World Forum for Harmonization of Vehicle Regulations**Working Party on Lighting and Light-Signalling****Seventy-first session**

**Regulation No. 48 (Installation of lighting and light-signalling devices) –
Proposal for amendments to the 06 series of amendments****Proposal for Supplement 3 to the 06 series of amendments to
Regulation No. 48 (Installation of lighting and light-signalling
devices)****Submitted by the expert from Poland***

Insert a new paragraph 6.2.6.1.3., to read:

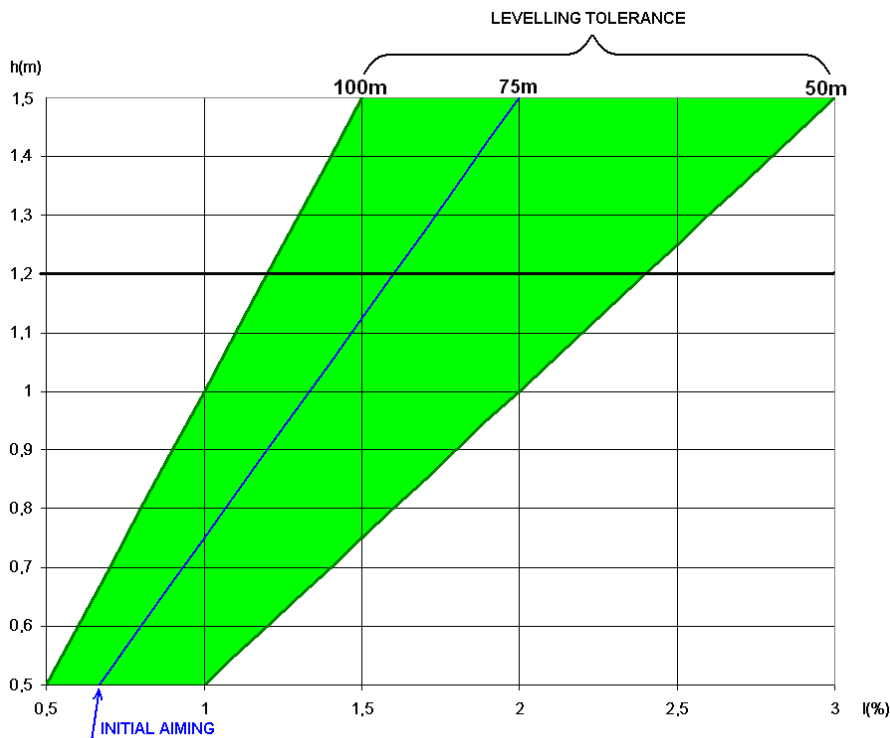
"6.2.6.1.3. Depending on the mounting height in metres (h) of the dipped-beam headlamp reference axis, the initial downward inclination of the cut-off of the dipped-beam shall have the value (initial headlamp aim) for which the horizontal part of the cut-off intersects with the surface of a flat horizontal road at a distance 75 m from the headlamp (see diagram below).

The vertical inclination of the cut-off of the dipped beam headlamp under all the static conditions of Annex 5 shall be such that the distance of intersection of the horizontal part of the cut-off with the road surface shall remain between 50 m and 100 m, including aiming inaccuracy (see diagram below).
